Bowie Mills Estates: Preliminary Plan No. 120140020

Staff Report Date: 10/10/14

Request to create four (4) lots from two existing undeveloped lots; located on the south side of Bowie Mill Road, approximately 300 feet east of Fraley Farm Road; 18.07 acres; RE-2 Zone; Upper Rock Creek Master Plan

# Attachment J

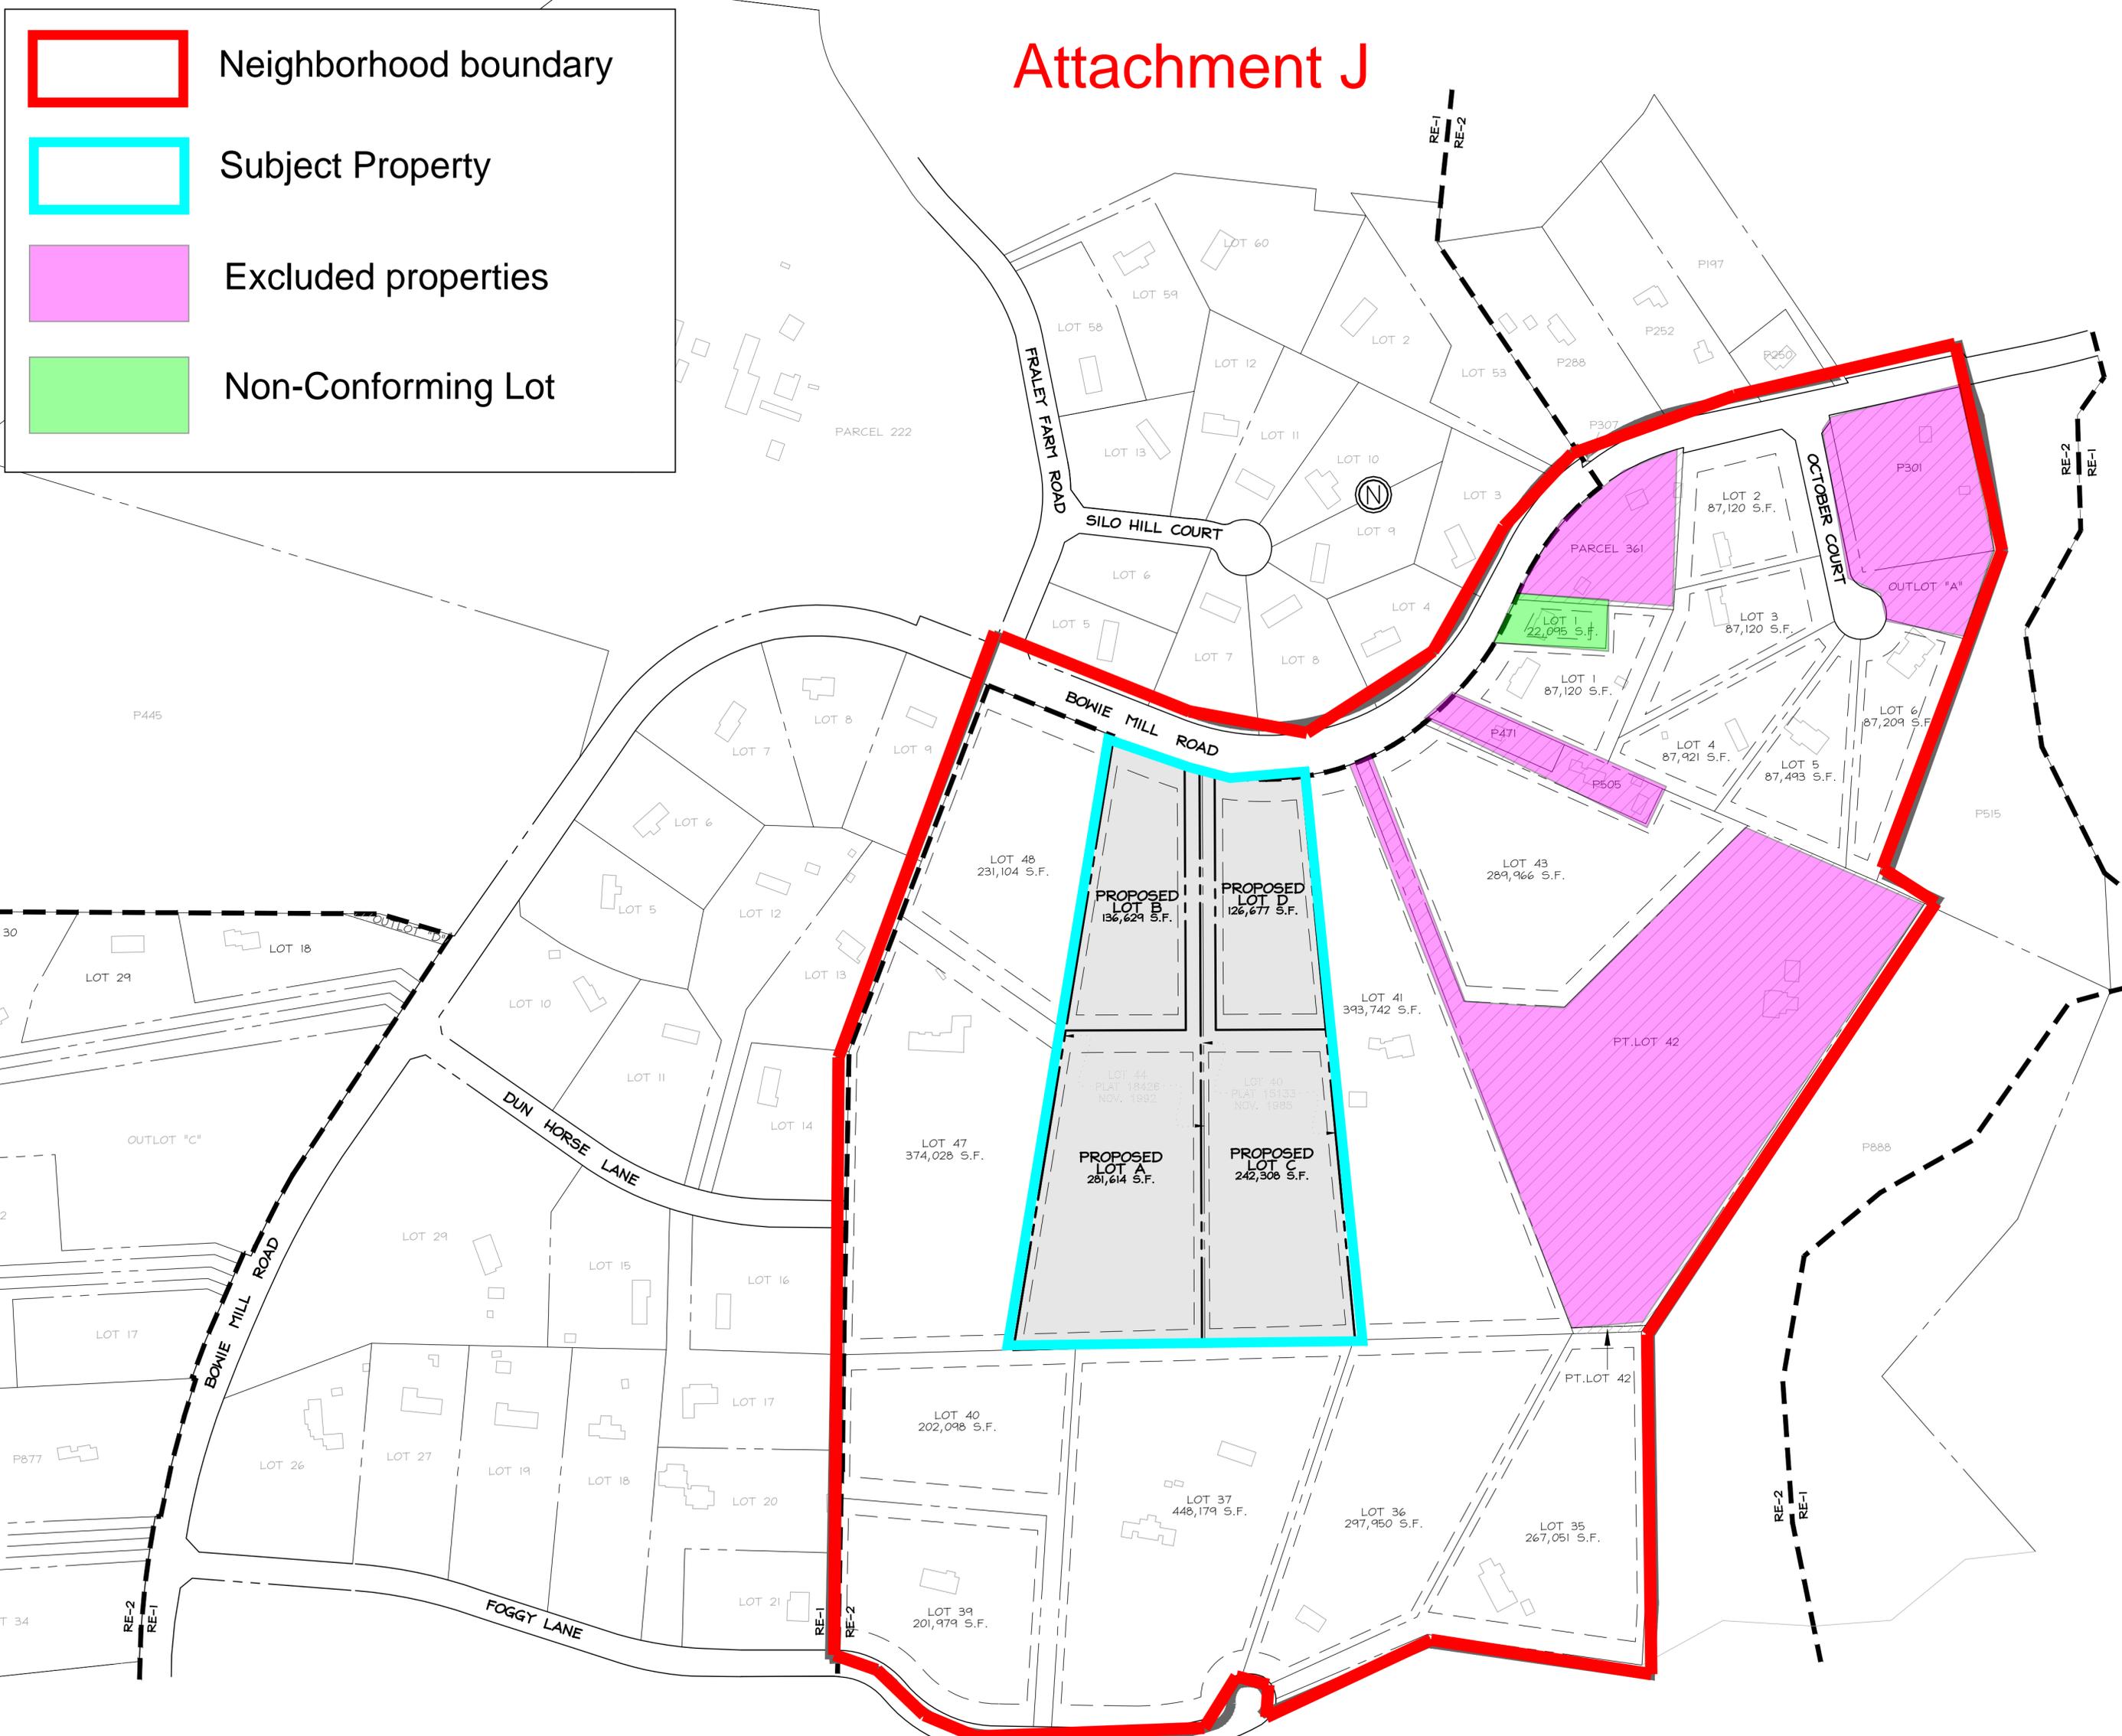
In performing the analysis, the above-noted resubdivision criteria were applied to the delineated Neighborhood. In all cases, the proposed lots had a high correlation with respect to the size, shape, width, area, alignment, frontage and suitability of existing lots in the Neighborhood. Therefore, the proposed lots are of the same character with respect to the resubdivision criteria as other lots within the Neighborhood. Therefore, the proposed resubdivision complies with the criteria of Section 50-29(b)(2). As set forth below, the provided tabular summary and graphical documentation support this conclusion:

The proposed lots will be of the same character as existing lots in the Neighborhood with respect to lot frontage. The two proposed pipestem lots have frontages of 35 feet and the rectangular lots have frontages of 169 and 202 feet. In the Neighborhood, the range of lot frontages is between 35 feet and 499 feet.

The proposed lots are of the same character as existing lots in the Neighborhood with respect to alignment. The alignment of the proposed lots is generally perpendicular to the street. Lots in the Neighborhood are a mix of perpendicular and parallel alignments.

The proposed lots sizes are in character with the size of existing lots in the Neighborhood. The range of lot sizes proposed by this Application is between 126,677 and 281,614 square feet. The range of lot sizes in the Neighborhood is between 87,120 and 448,179 square feet.

The shape of the proposed lots will be in character with shapes of the existing lots in the Neighborhood. Two of the four proposed lots are pipestem in shape, and two are rectangular. The Neighborhood contains a mix of lot shapes including pipestem, rectangular, triangular and irregular shapes.

The proposed lots will be in character with existing lots in the Neighborhood with respect to width. The range of width at the building line for the proposed lots is between 219 and 362 feet. The range of lot width within the Neighborhood is between 142 and 475 feet.

The proposed lots will be of the same character as existing lots in the Neighborhood with respect to buildable area. The proposed lots have buildable areas that are between 91,291 and 208,942 square feet; within the range of buildable areas for lots in the Neighborhood which range between 44,022 and 374,463 square feet.
